Product Service Group CE Audio

Service Information

MCU & VCD BOARD

CHANGES DURING PRODUCTION

CIRCUIT DIAGRAM - MCU & VCD BOARD

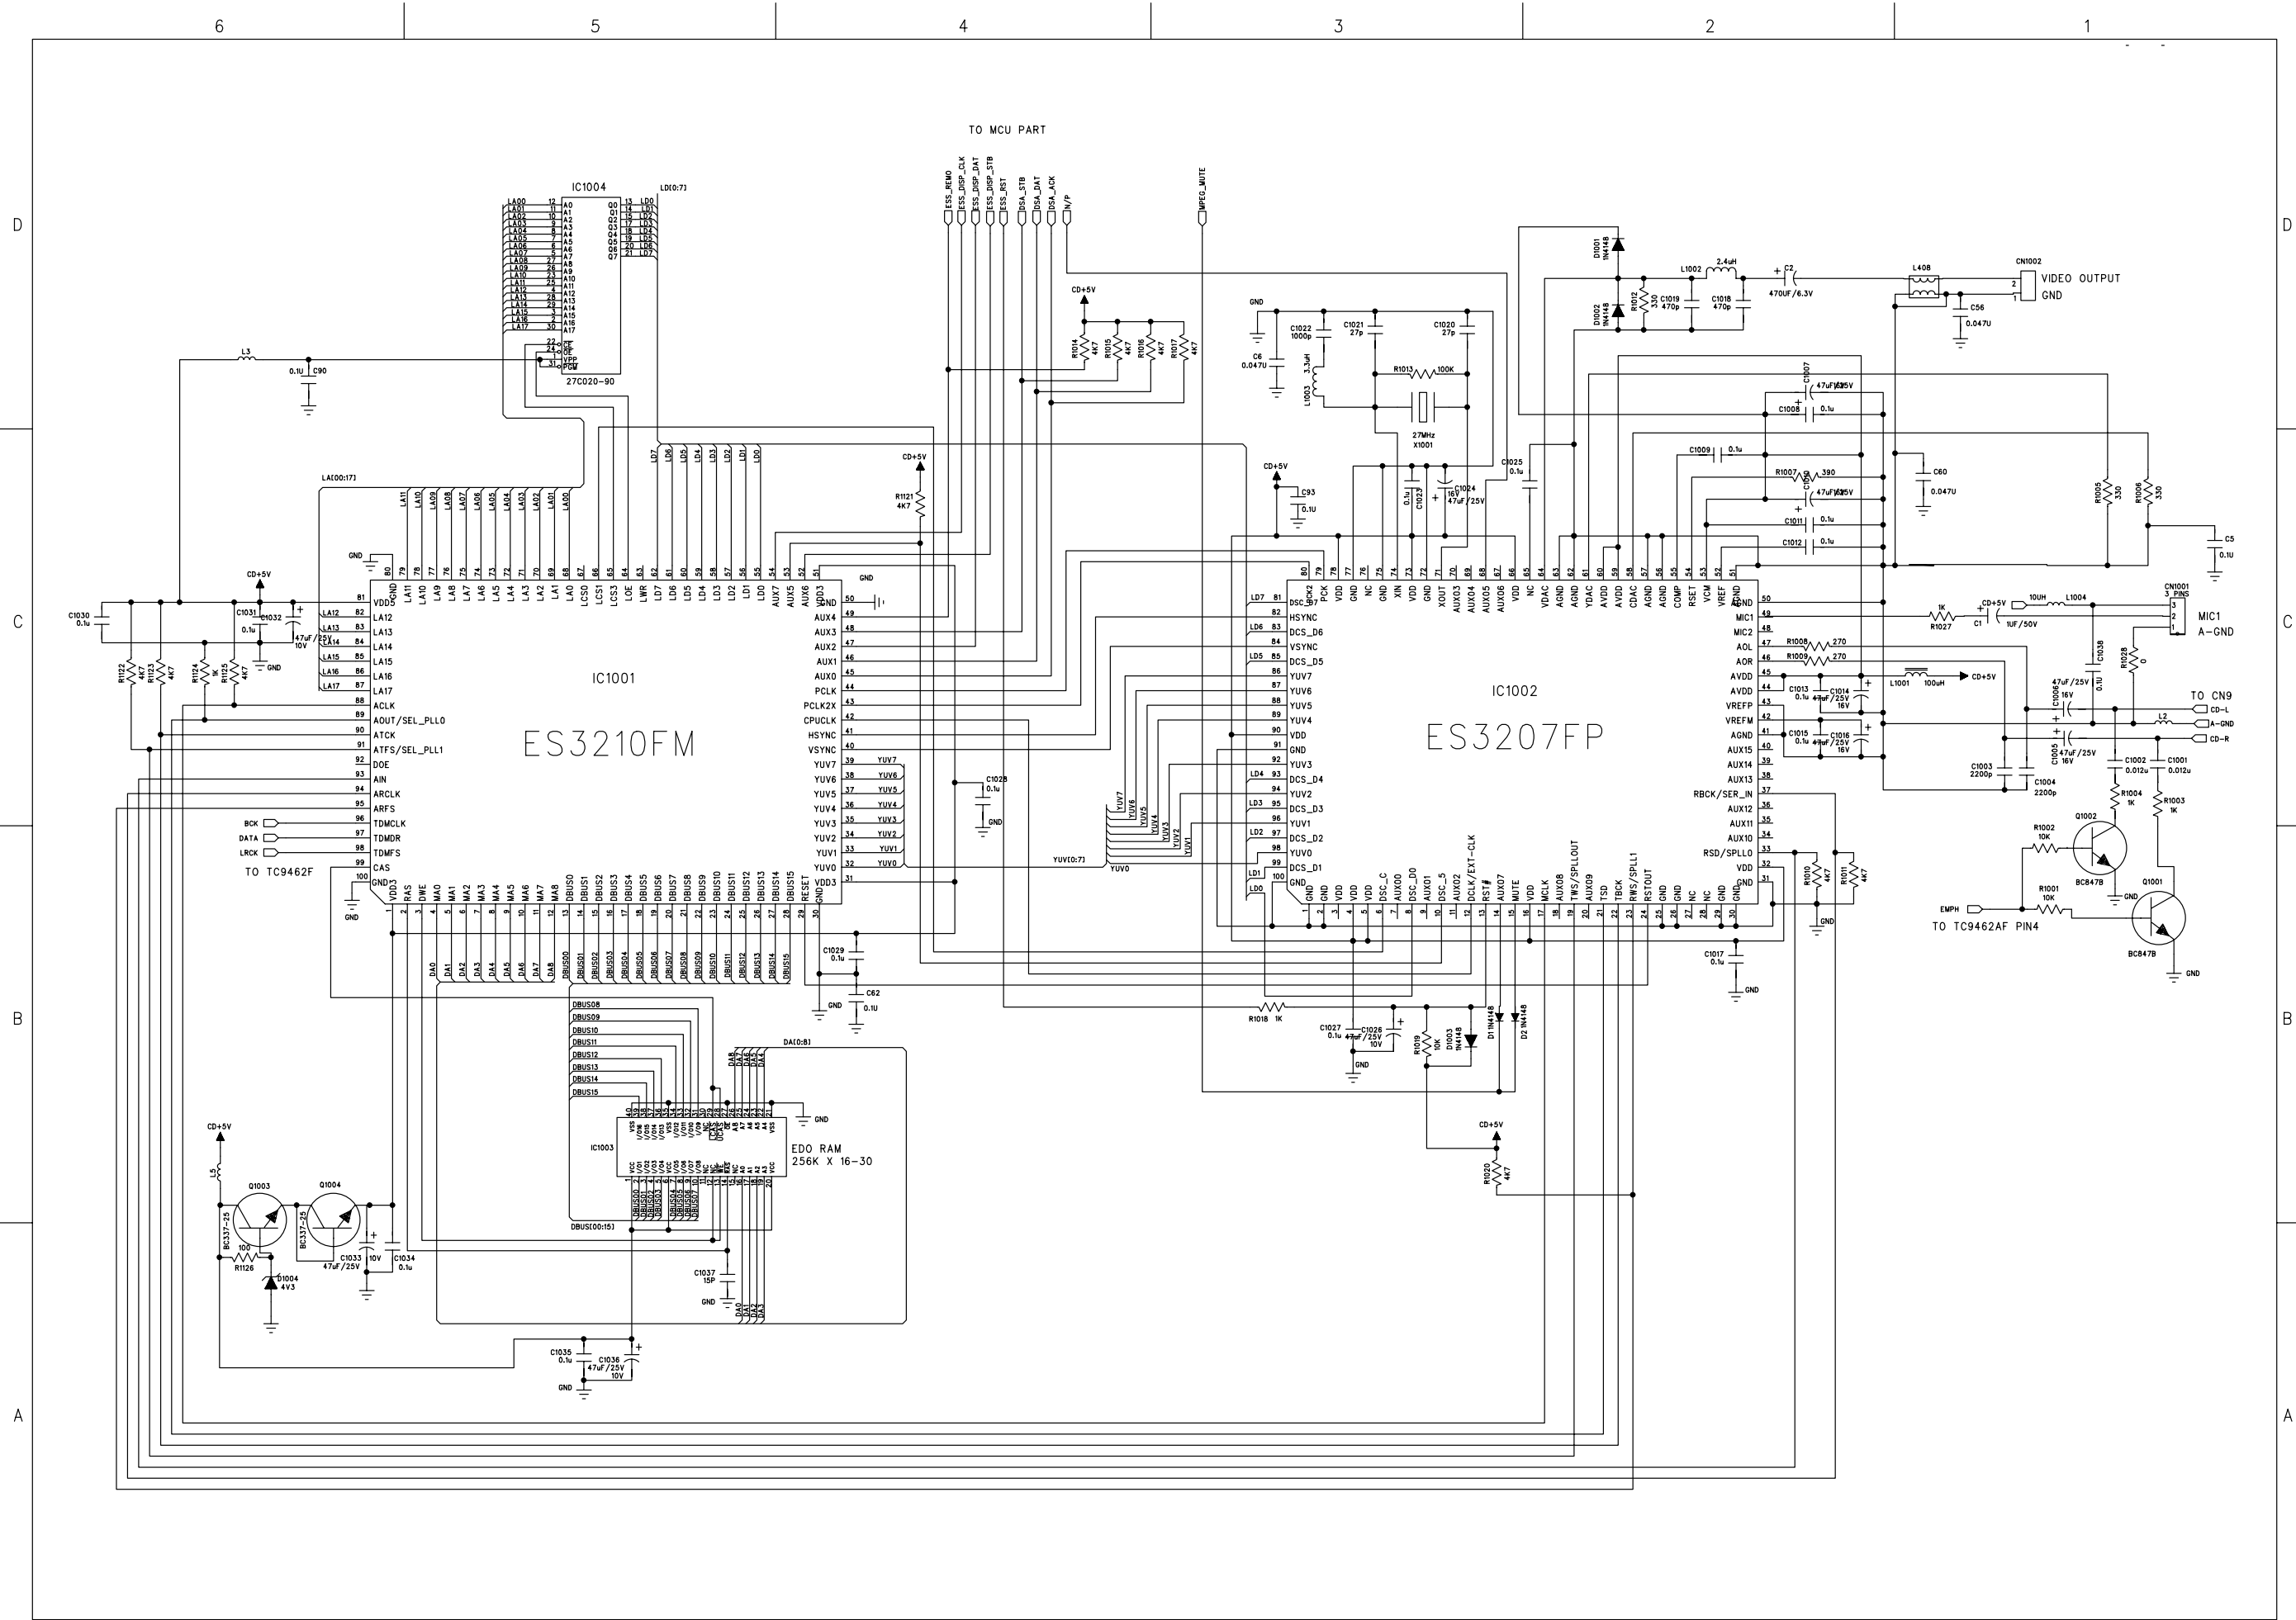
*From production week 0330 onwards the MCU & VCD board has been modified in order to eliminate the pink noise during CD playing.

Add IC1 5322 209 11548 MC74HC14AD

For servicing the new MCU & CD board, please refer to the attached pages.
